CLEVIS ADDITION TO FIRETOWER ROAD **SUBDIVISION**

APPLICATION NUMBER 18 DATE July 10, 2008

DETAIL SITE PLAN

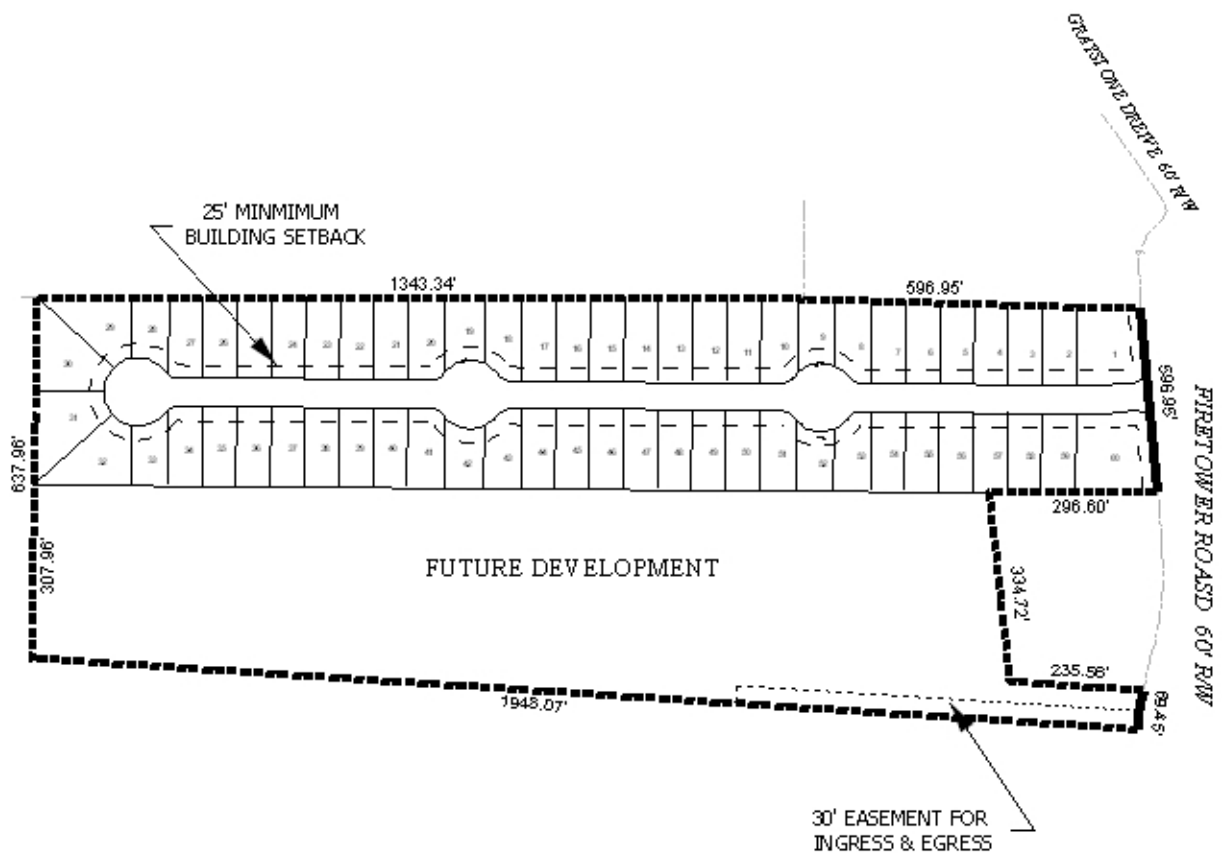
The site involves the creation of a new street off of Firetower Road, a minor street with an adequate right-of-way of 60-feet. The new street must be constructed and dedicated to County Engineering standards; however, the new street is approximately 1,673-feet long and is illustrated as providing two turnarounds (traffic circles) and ends into a cul-de-sac. Furthermore, Section V.B.1. (Street layout) states the "*street layout shall provide for the future projection into unsubdivided lands adjoining of a sufficient number of streets to provide convenient circulation.*" Therefore, street stubs would be required to the large undeveloped parcels to the North (160+ acres) and South 87+ acres), as the northern acreage was a large part of the proposed Hopkinton Estates Subdivision that was denied by the Commission in December 2007. The street stubs should be located in the vicinity of lots 18-20 to the North and lots 41-43 to the South.

In addition, as a means of access management, a note should be placed on the final plat stating that all corner lots be limited to one curb cut each, with the size, design and location to be approved by County Engineering and conform to AASHTO standards. Also, a note on the Final Plat stating that lots 1 & 60 be denied direct access to Firetower Road should be required.

The preliminary plat does not depict a detention area, while the site is in the county, compliance with the City of Mobile storm water and flood control ordinances will be required. A letter from a licensed engineer certifying compliance with the City's stormwater and flood control ordinances should be submitted to the Mobile County Engineering Department and the Planning Section of Urban Development prior to the issuance of permits.

- 1) the provision of street stub between lots 18-20 to the North and a street stub between lots 41-43 to the South;
- 2) the placement of a note on the Final Plat stating that all corner lots are limited to one curb cut each, with the size, design and location to be approved by County Engineering and conform to AASHTO standards;

- 3) the placement of a note on the Final Plat stating that direct access to Firetower Road from Lots 1 & 60 is denied;
- 4) the labeling of all common areas and the placement of a note on the Final Plat stating that maintenance of common areas will be property owners' responsibility;

- 6) labeling of each lot with its size in square feet, or the provision of a table depicting the same information;
- 7) The provision of the submittal of a Traffic Impact Study (TIS) at the same time a preliminary subdivision application is submitted to access this subdivision;
